2020 Corvette: Service Bulletin:: #20-NA-179: Malfunction Indicator Lamp (MIL) Illuminated - DTCs P0521 and/or P06DD Set - (Oct 23, 2020)

Subject: Malfunction Indicator Lamp (MIL) Illuminated – DTCs P0521 and/or P06DD Set

Brand:	Model:	Model Year:		VIN Breakpoint:		Engine:	Transmission:
		from	to	from	to		
Chevrolet	Corvette	2020	2020	SORP	September 10, 2020	6.2L (LT2)	—

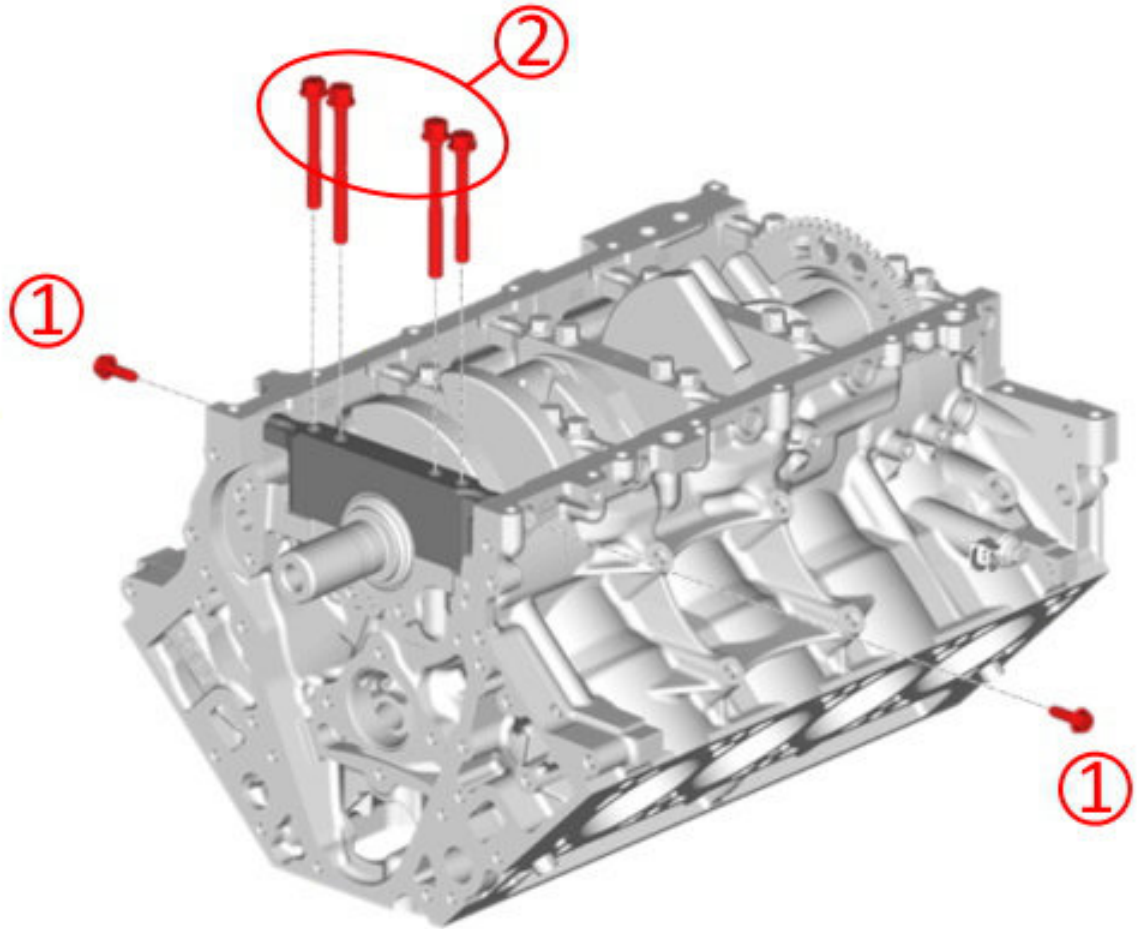
If P0521 and P06DD DTCs are present, then a redesigned oil pressure control valve retainer clip (1) may be necessary. Refer to the Service Procedure section below.

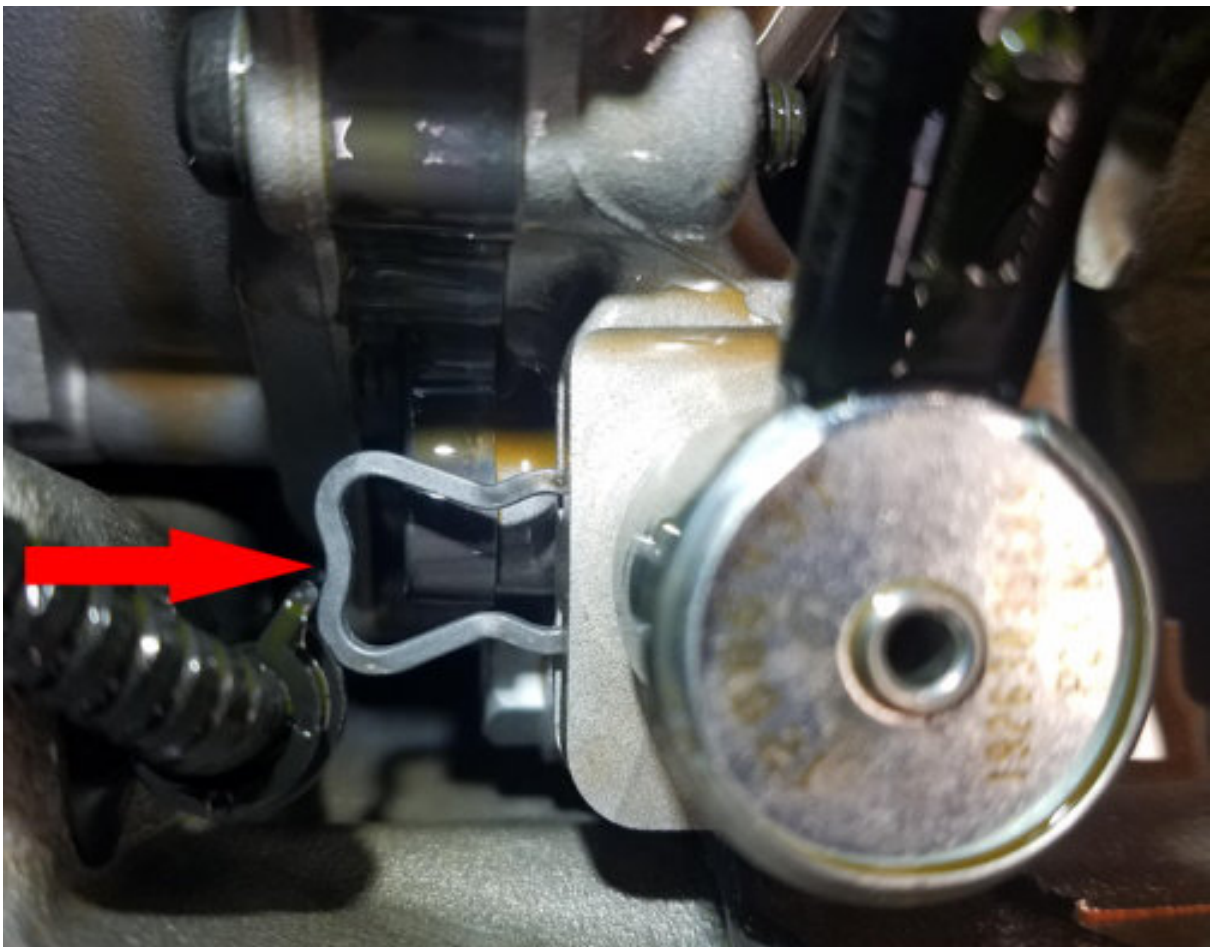
1. Inspect the OCV:
 - If you find this oil pressure control valve dislodged (1), it will be necessary to install a redesigned oil control valve retainer.
- Disconnect the oil pressure control valve electrical connector and position aside.

Note: Remove the existing oil pressure control valve retainer by pulling towards the rear and discard. You will be installing a newly designed retainer during installation.

1. Install the new retainer from the front of engine towards the rear as shown in the graphic above.

1. When the retainer is installed, there should be about 2 to 3 mm of clearance between the retainer and the oil pump body as shown above.
